REF	QTY	PART or DRWG No.	DESCRIPTION	MATERIAL
			PARTS and MATERIAL LIST	
<b>LIGO</b> CALIFORNIA INSTITUTE OF TECHNOLOGY MASSACHUSETTS INSTITUTE OF TECHNOLOGY				
<b>PLATE, EMT INTERFACE</b>				
			kenm	6-2-99
00			CHAPUT	11-3-98
REV		DCN NUMBER	APPR'D	CHECK
			DRWN	DATE
CAD FILE: D980631-B.DWG SIZE: C DWG. NO.: D980631-B				SCALE: 1 : 1 SHEET: 1 OF 1

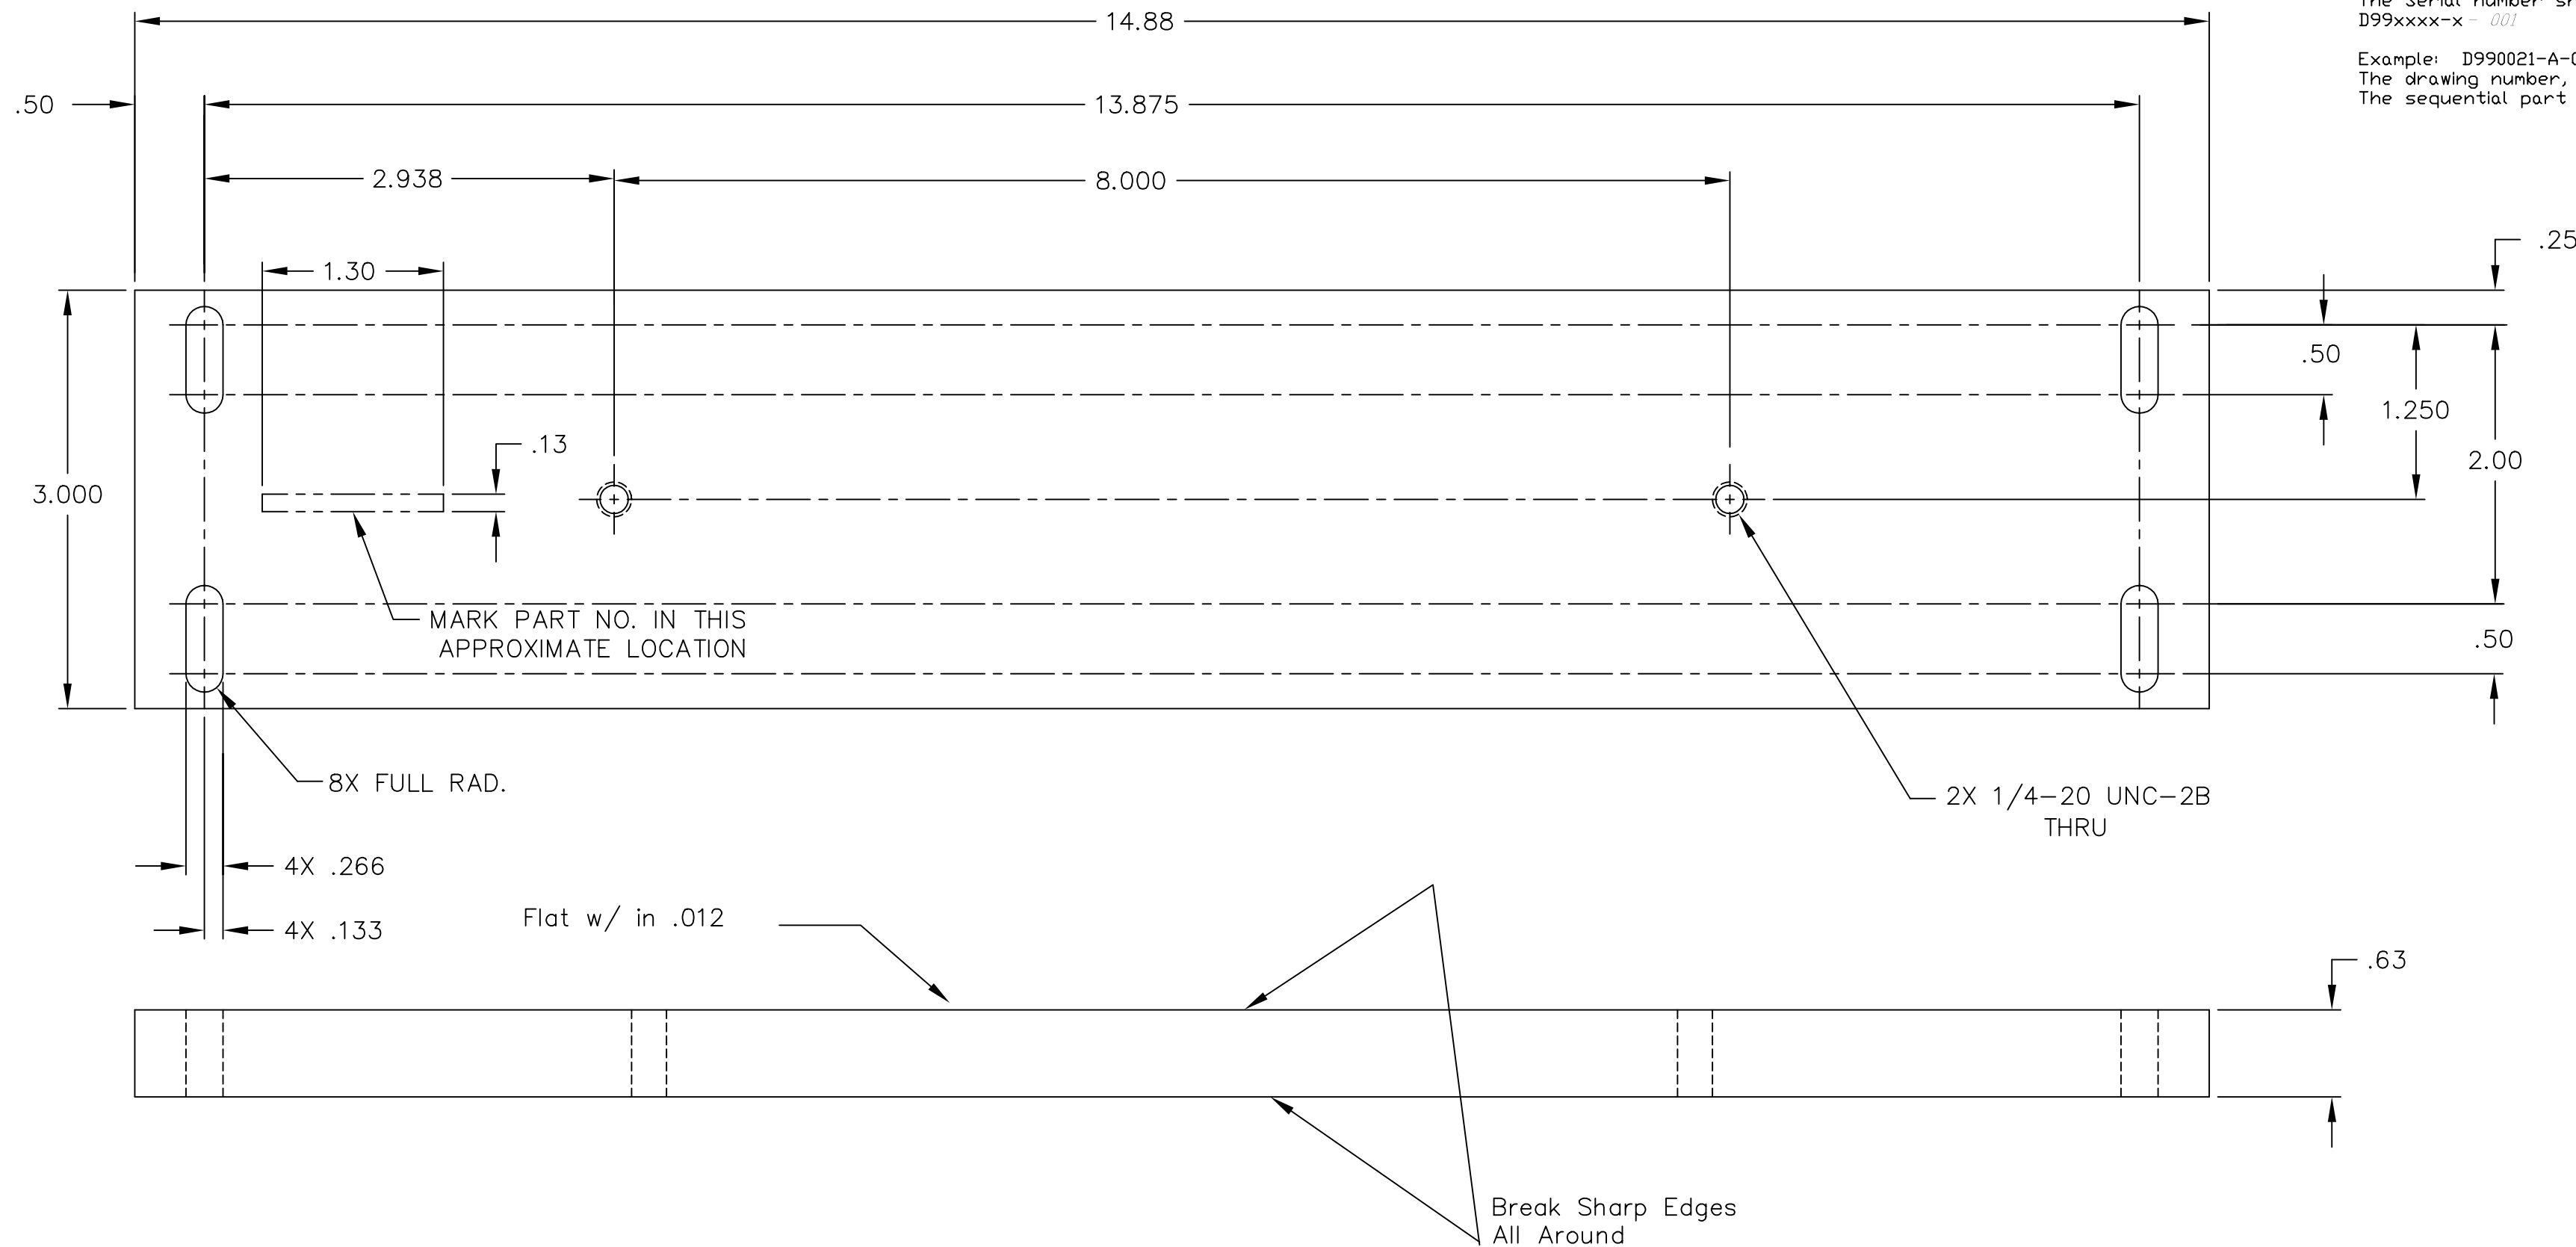
~~Liquid contaminants/Machining Lubricants~~  
 Liquids containing hydrocarbons or other contaminants, other than the machining fluids specified herein, shall not be allowed to come into contact with suspension material at any time. All machining fluids shall be water soluble and free of sulfur, chlorine and silicone; such as Cincinnati Milacron's Cimtech 410 (stainless steel).

*Identification\_Serial Number*  
 A serial number shall be etched, or scribed on the part see note drawing note.
